DEPARTMENT OF NATURAL RESOURCES
DIVISION OF OIL, GAS AND MINING

December 13, 1988

RE: Determination of Runoff Volume Expected from a 100 yr. -24 hr. Precipitation Event Reporting to Upper and Lower Refuse Ponds and Clear Water Pond, Wellington Coal Preparation Plant, Kaiser Steel Corporation, ACT/007/012, Carbon County, Utah

APPROVED:
A9-1429

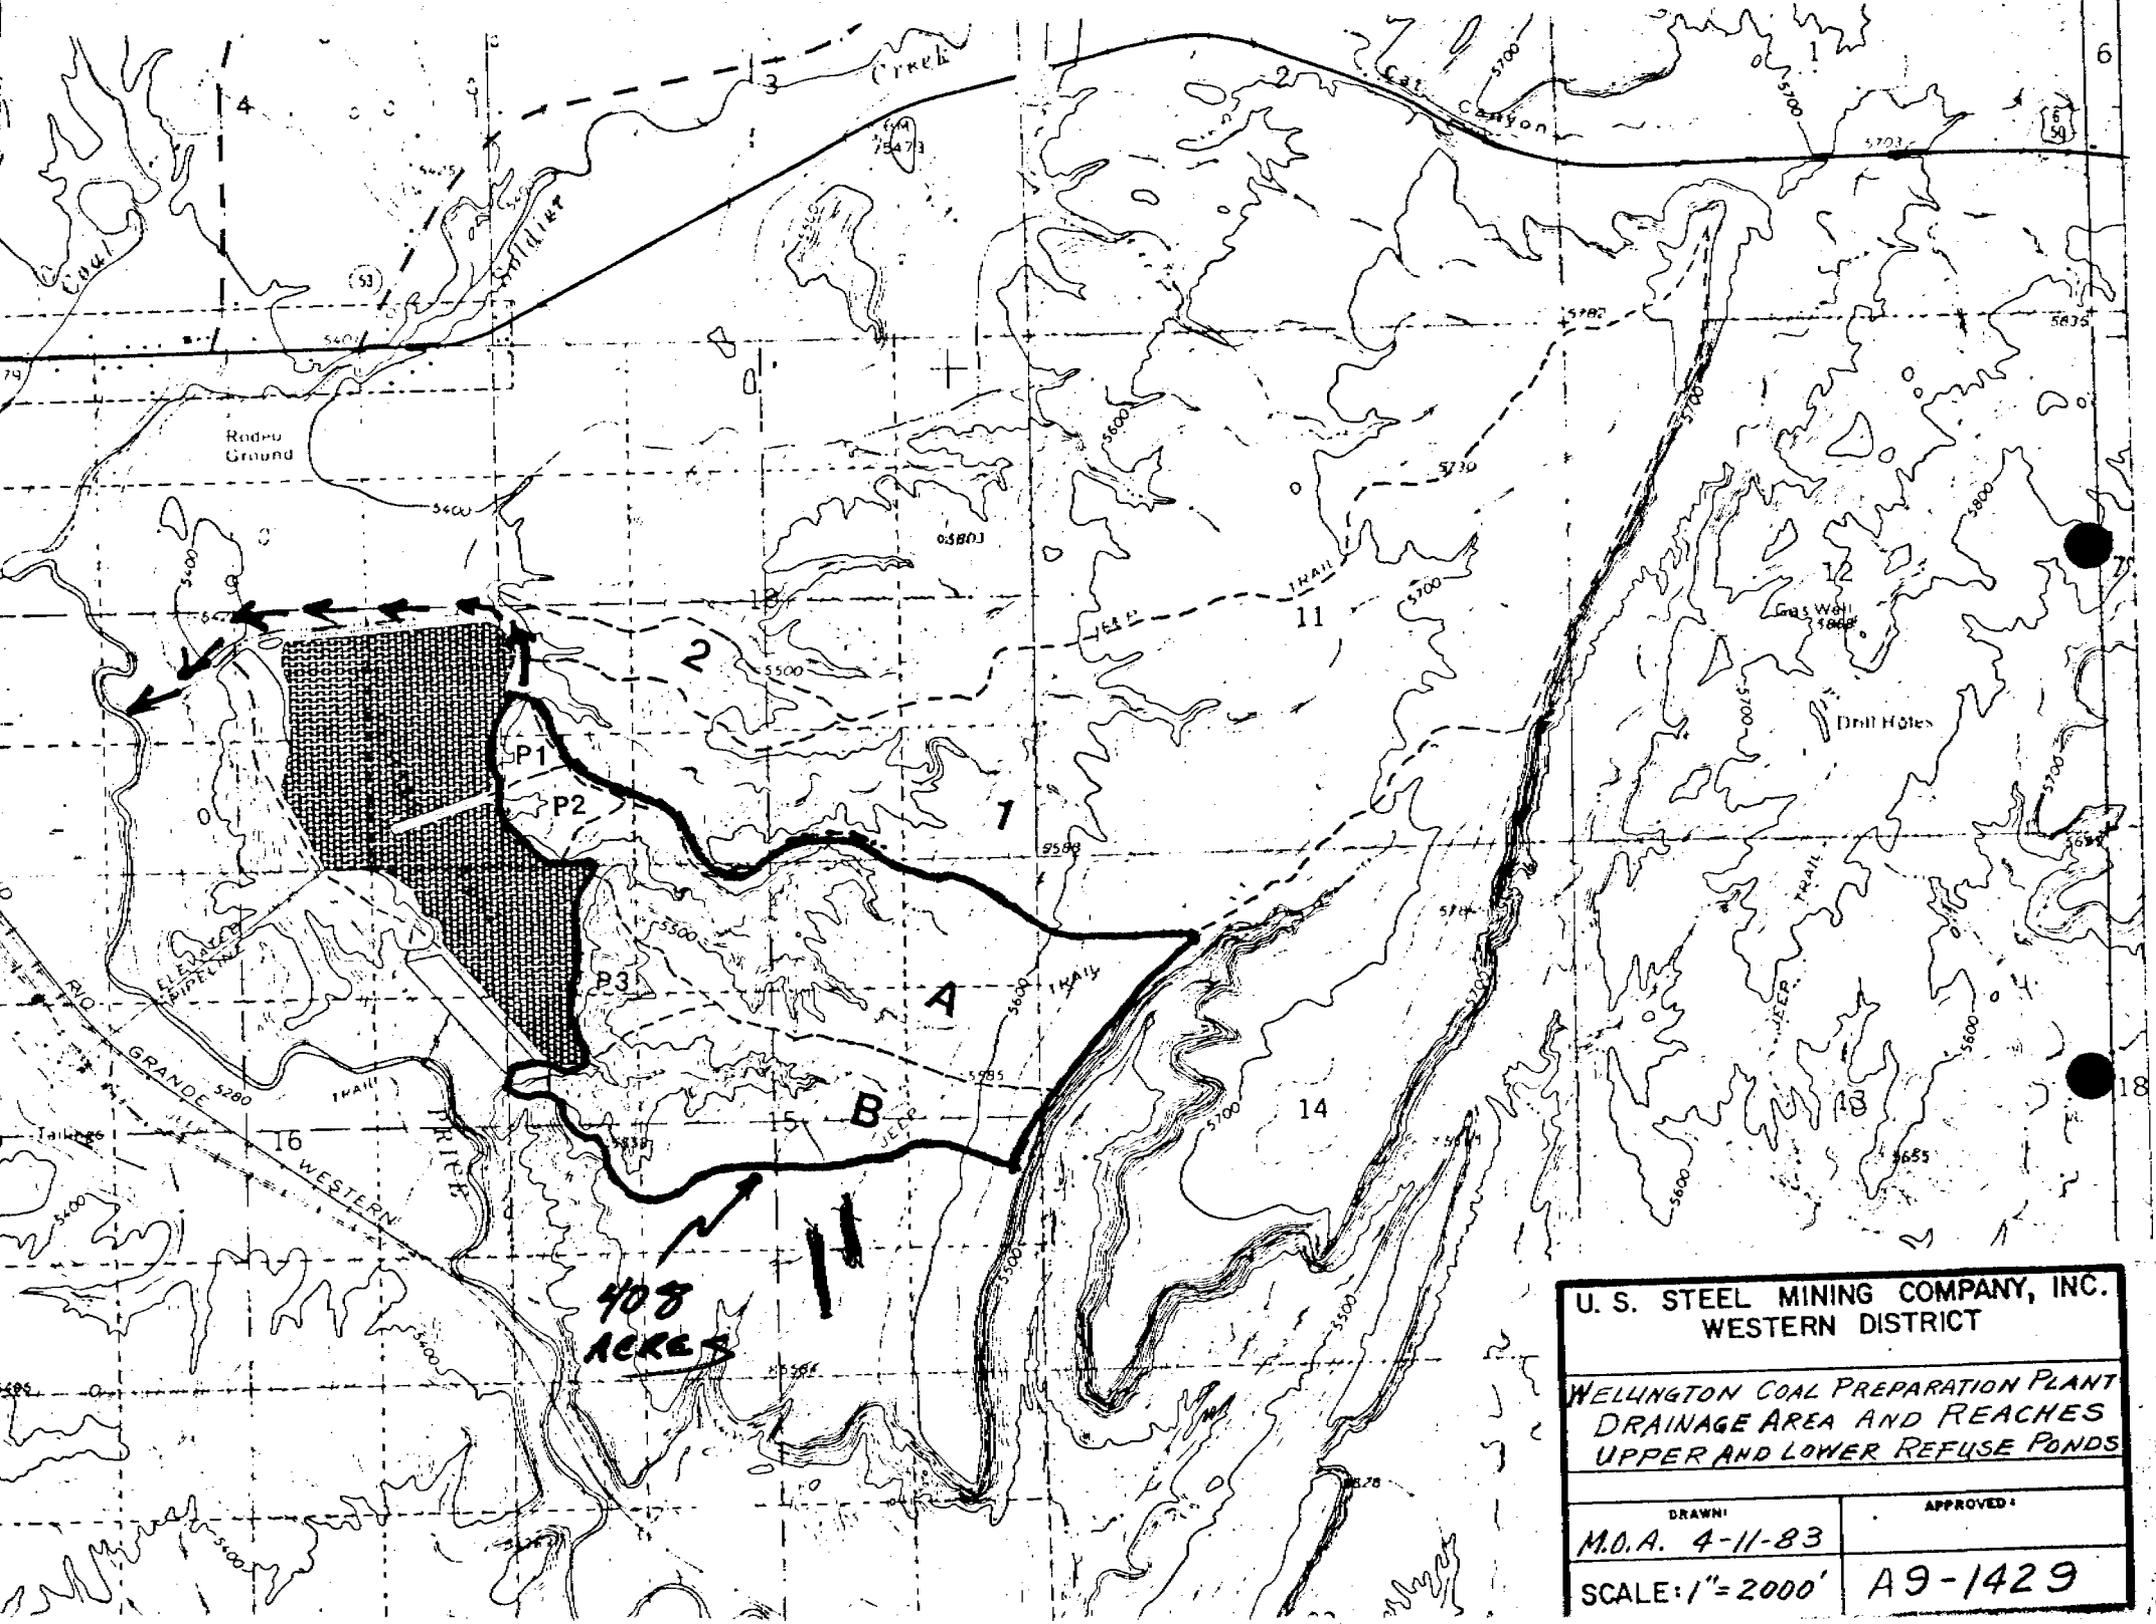
The runoff volume calculations were performed using accepted Soil of Conservation hydrologic techniques (SCS, NEH -4, 1972). Plate A9-1429 contained in Volume 3 of the MRP (attached) was used to determine the drainage areas reporting to the aforementioned structures. Watersheds P1, P2, P3, A, and B were digitized to determine the acreages involved. The total area was found to be 408.34 acres. The Division assumed a curve number of 85 (actual value is 84.16) from the MRP (Sheet 1 of 23, Appendix A, Volume 3), and a precipitation value of 2.74 inches (Page B-17, Rev. 1: 6-30-83, Vol. 3) for a 100 yr. - 24 hr. precipitation event. Using those assumptions, the runoff volume for this area can be expected to be 46.7 ac-ft.
